Note to Landmarks Commission: 129 W Gorham Street / 120 W Johnson Street Mansion Hill Local Historic District and Landmark Site

Re: Proposal for a new 5-story apartment building on the site of the Holy Redeemer R.C. Church and School. The site of the proposed apartment building is currently used as a parking lot, and will not require any demolition of historic structures.

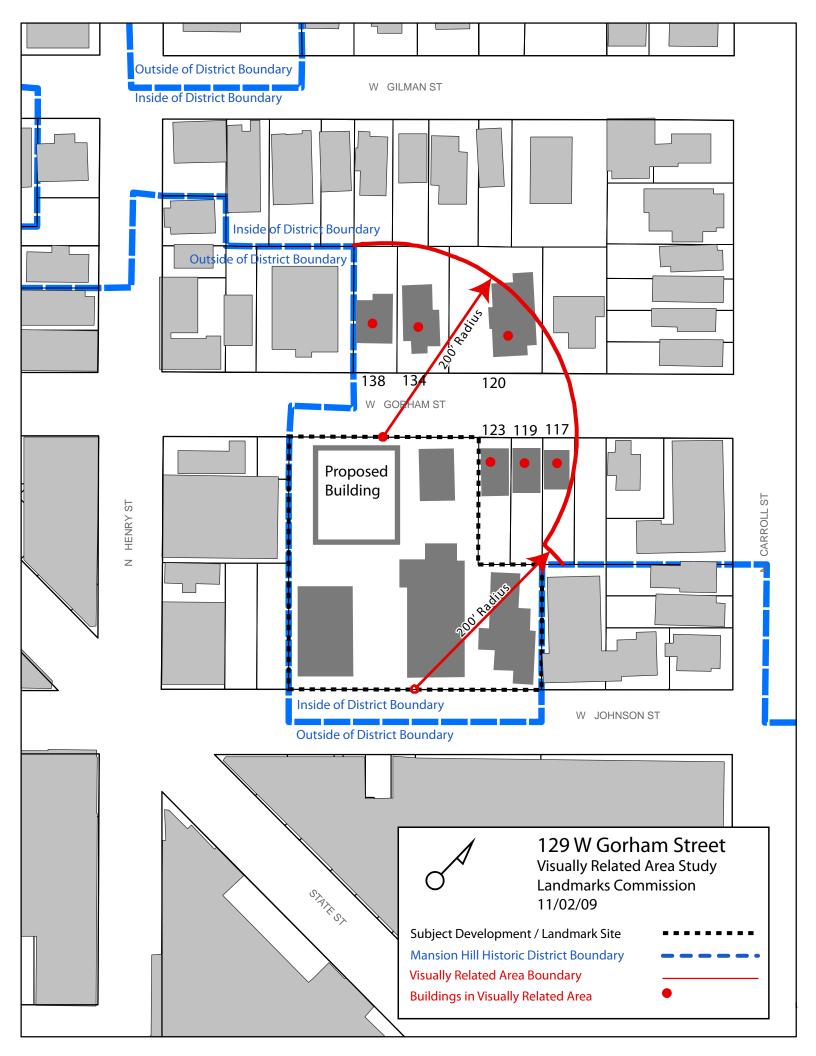
- 1. The rear (south) façade should have a more modulated façade instead of a flat façade, considering that it will be clearly visible from both of the two landmark buildings and West Johnson Street.
- 2. High quality building materials should be used on all sides of the building. Consider replacing the EIFS with brick, stone, cement fiber board, or other durable materials.
- 3. A more complete and integrated landscape plan is needed to help resolve the relationship between the new building and the existing church and school. This should include additional plantings along the back side of the building that faces the school.
